Tyres: UN Regulation No. 117 (Tyre rolling resistance, rolling noise and wet grip)

Proposal for Supplement 2 to the 04 series of amendments to UN Regulation No. 117

Submitted by the experts from the European Tyre and Rim Technical Organization*

Figure 1

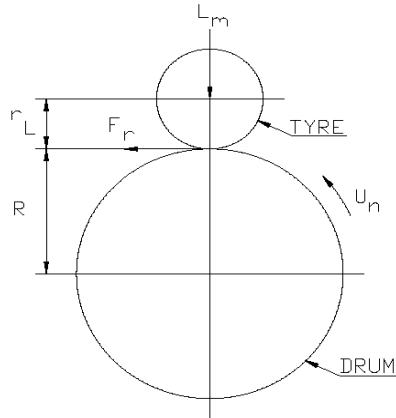
Paragraph 4.5., amend to read:

The following shall be measured and recorded (see Figure 1):

- (a) Test speed U_n ;
- (b) Load on the tyre normal to the drum surface L_m ;
- (c) The initial test inflation pressure as defined in paragraph 3.3. above;
- (d) The coefficient of rolling resistance measured C_r , and its corrected value C_{rc} , at 25 °C and for a drum diameter of 2 m;
- (e) The distance from the tyre axis to the drum outer surface under steady state $r_{L,}$;
- (f) Ambient temperature t_{amb} ;
- (g) Test drum radius R;
- (h) Test method chosen;

- (i) Test rim (size and material);
- (j) Tyre size, manufacturer, type, identity number (if one exists), speed category symbol, load index, DOT number (Department of Transportation).

All the mechanical quantities (forces, torques) will be orientated in accordance with the axis systems specified in ISO 8855:1994/2011.

The directional tyres shall be run in their specified rotation sense."
